MESA DEL SOL
ARCHITECTURAL CONTROL COMMITTEE
SITE DEVELOPMENT PLAN REVIEW

MESA DEL SOL SELF STORAGE
SITE PLAN
5500 TURING DR SE
ALBUQUERQUE, NM 87106
PROJECT #2322

**RE: Mesa Del Sol Self Storage
5500 Turing Dr. SE
Grading and Drainage Plan
Engineer's Stamp Date: 5/7/2025
Hydrology File: R16DA1004**

**Re: Mesa Del Sol Self Storage
 5500 Turing Dr. SE
 Grading and Drainage Plan
 Engineer's Stamp Date: 01/15/2025
 Hydrology File: R16DA1004**

AS-1.0

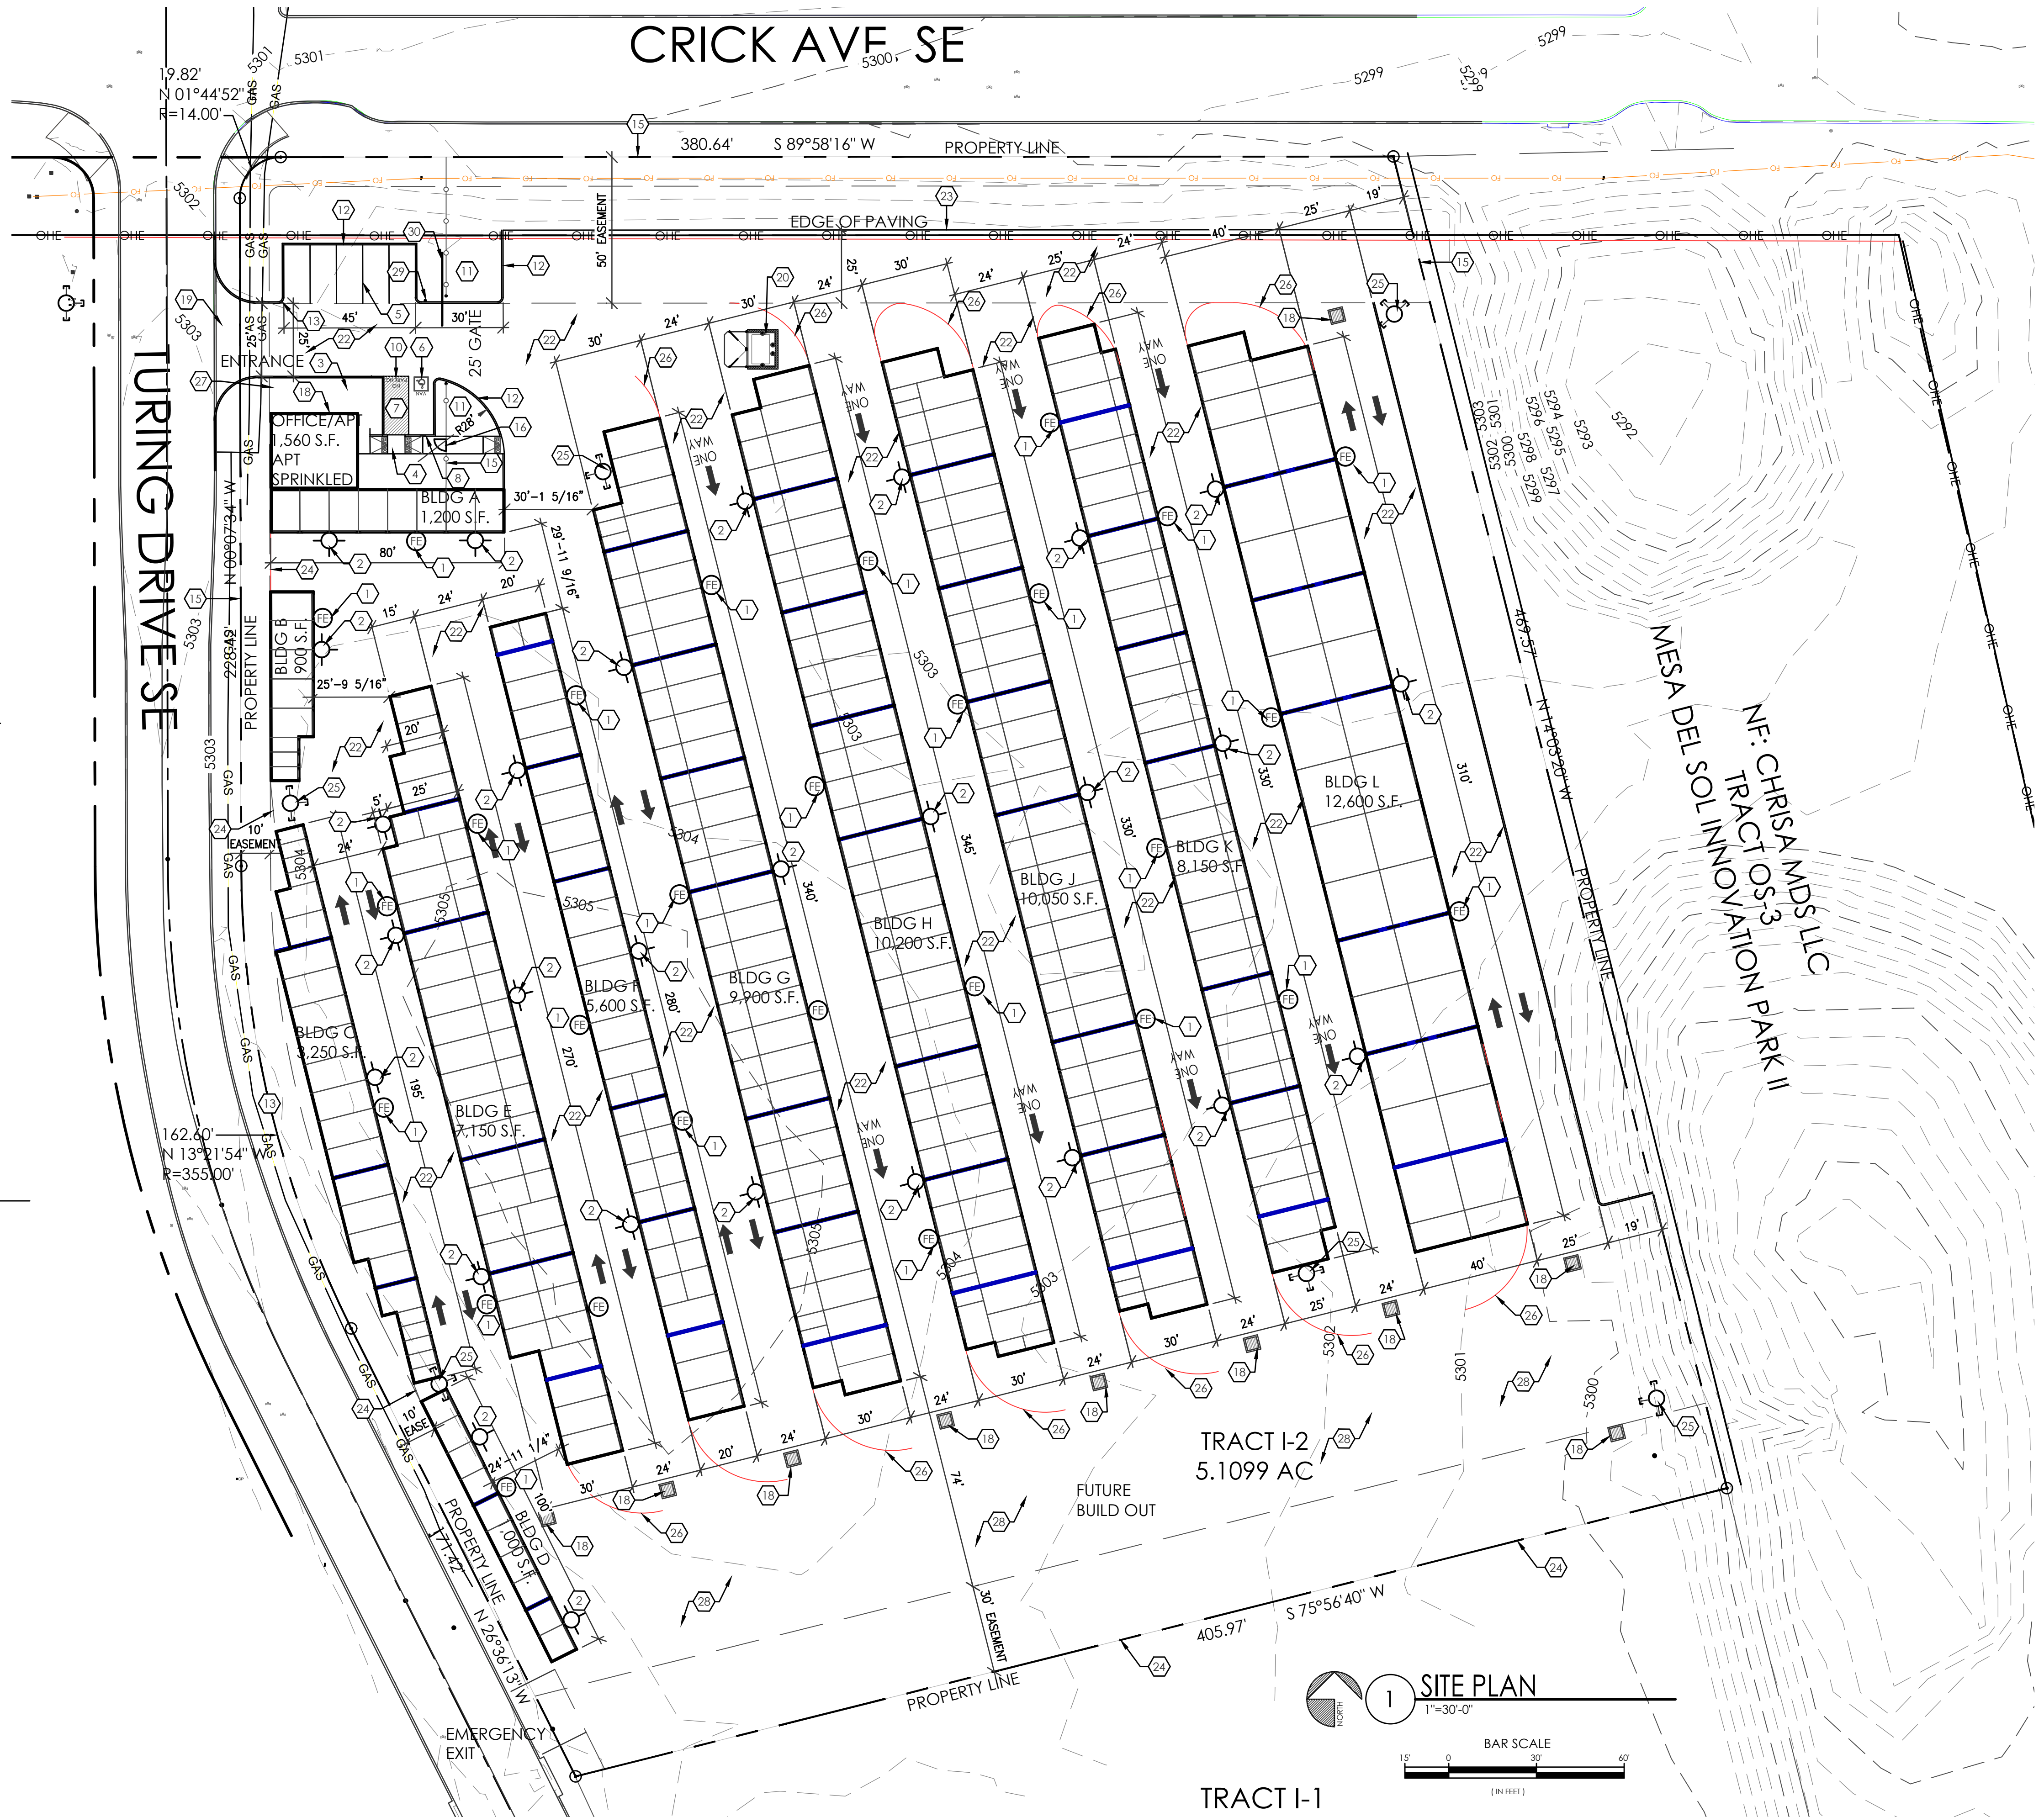
Approved for access by the Solid Waste Department.

All containers must be made accessible for pick up

between the hours of 5AM and 8PM.

Keypad access

Gate will open 25' clear

Recycling declined

C-3.0

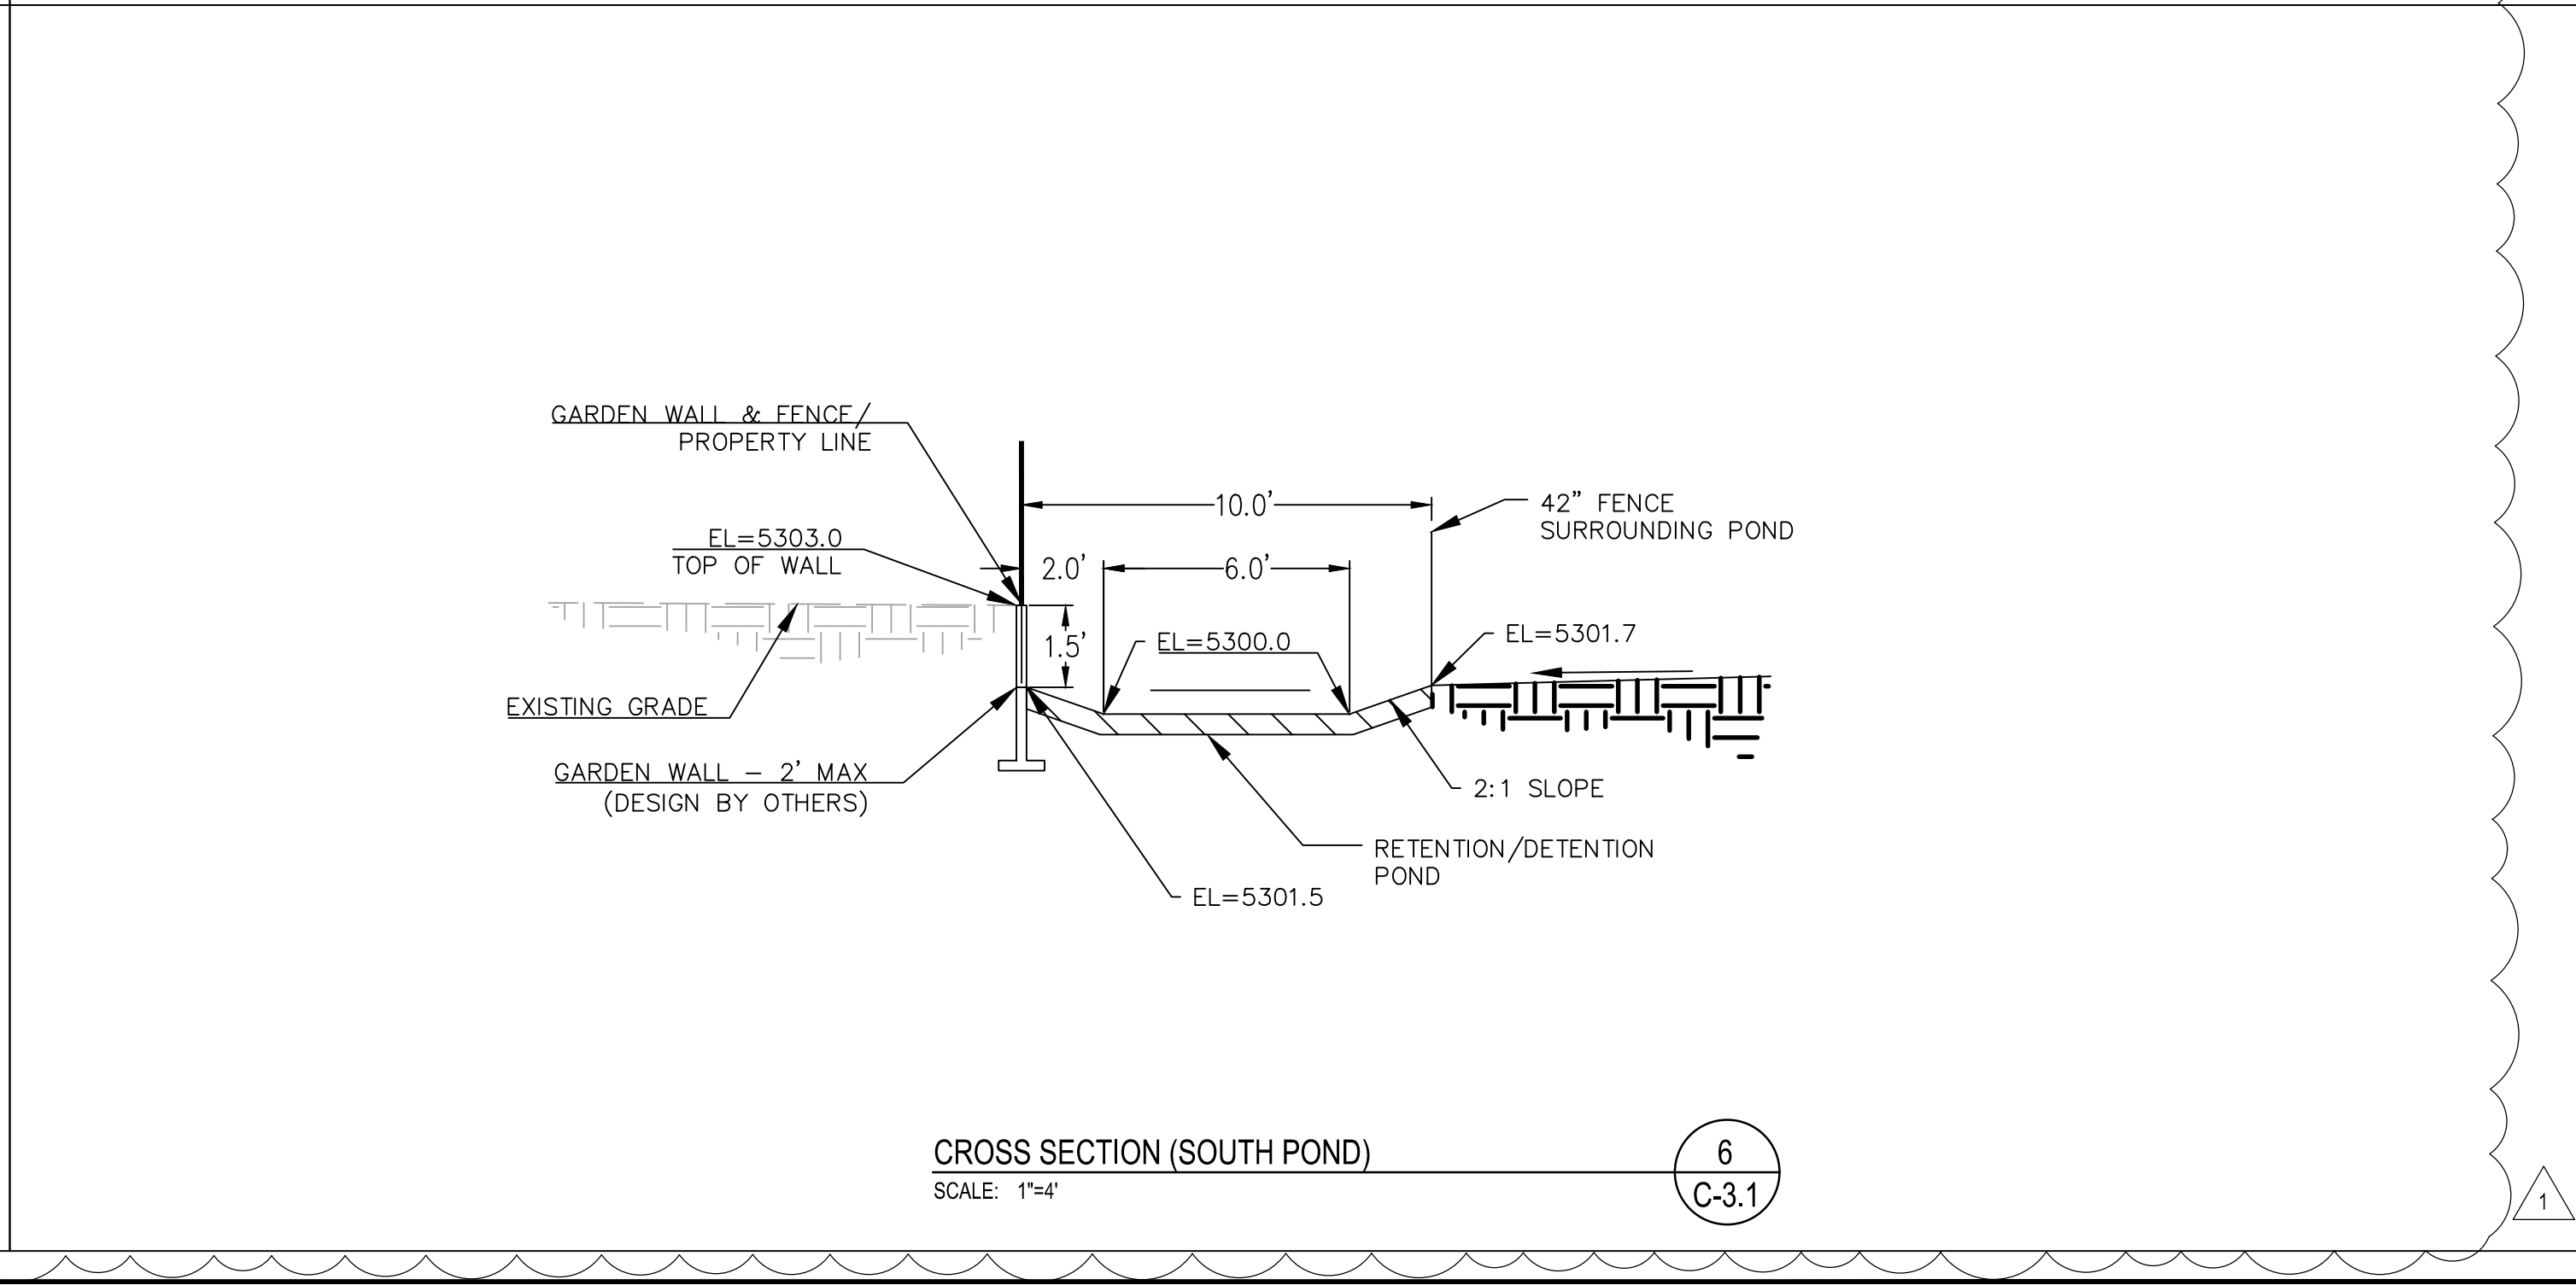
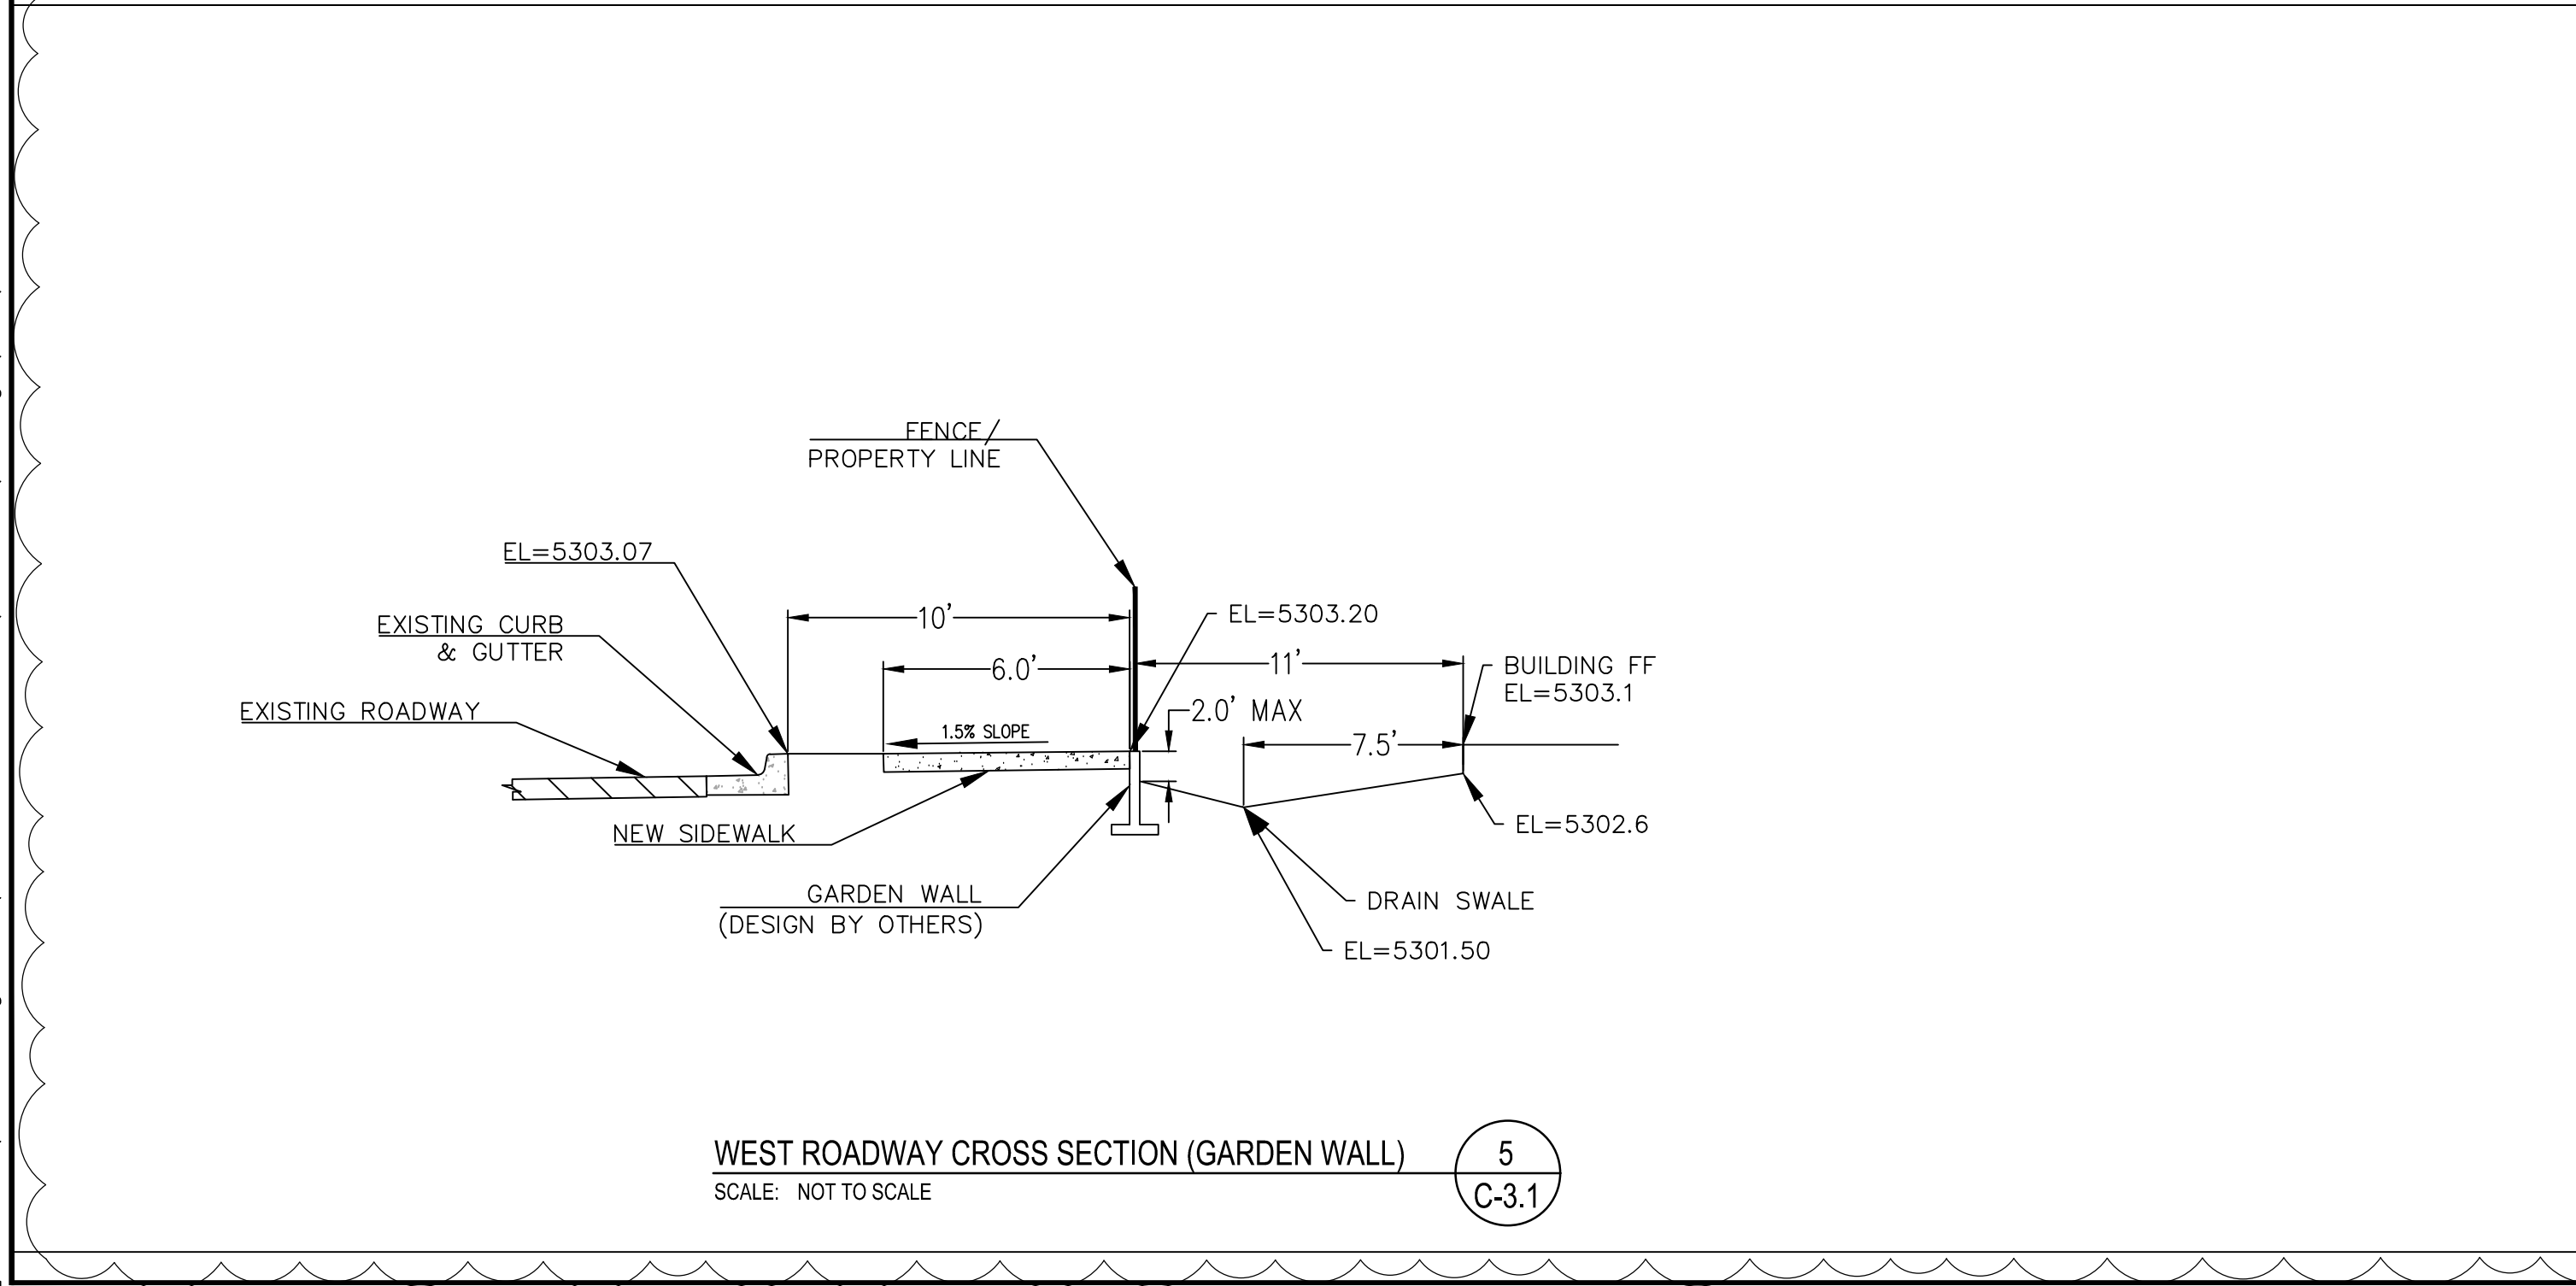
REVISIONS	NO.	BY	DATE	REMARKS
	1	NV5	5/7/25	HYDROLOGY COMMENTS DATED 3/21/25
